APPLICATION NO.	FILING DATE	FIRST NAMED INVENTOR	ATTORNEY DOCKET NO.	CONFIRMATION NO.
10/814,658	03/31/2004	Xavier Catry	BDLLE-456XX	5982
207	7590	04/05/2005	EXAMINER	
WEINGARTEN, SCHURGIN, GAGNEBIN & LEOVICI LLP TEN POST OFFICE SQUARE BOSTON, MA 02109			WELCH, GARY L	
			ART UNIT	PAPER NUMBER
			3765

Office Action Summary	Application No.	Applicant(s)	
	10/814,658	CATRY ET AL.	
	Examiner	Art Unit	
	Gary L. Welch	3765

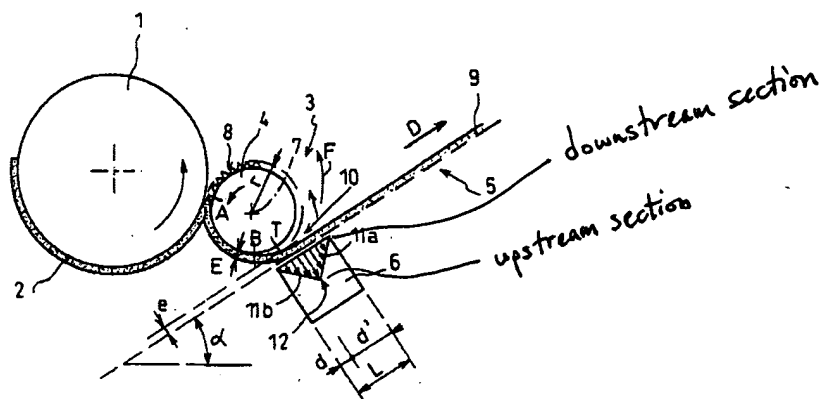
However, Lovgren et al. does not disclose that the vacuum means provides a reduction in vacuum speed between the upstream and downstream parts of the vacuum zone.

Brabant et al. teaches a machine for making a non-woven material by aerological means. The machine comprises a forming and conveying surface 5 that is air permeable, a dispersion cylinder 4 surmounting the forming and conveying surface, means 1 for supplying the dispersion chamber with fibers and vacuum means 6 located under the forming and conveying surface that produces an air flow that allows the fibers to disperse and project onto the surface. The vacuum means 6 creates a reduced suction from an upstream location (see figure below) to a downstream location (Col. 7, lines 38-54 and Col. 8, lines 16-22). This varying suction enables the machine to remove and convey a web from a prior fiber processing machine (i.e., carder, etc.) wherein the web has a weight range from 50 g/m² to 100 g/m² at high operating speeds such as 300 m/min while conserving the isotropic mechanical properties of the web (i.e., no web stretching).

With regard to claim 28, only one second stage is provided wherein the vacuum speed decreases gradually from upstream to a downstream section (see figure above).

With regard to claim 29, the secondary section is a vacuum zone and has a plurality of successive stages (see figure above).
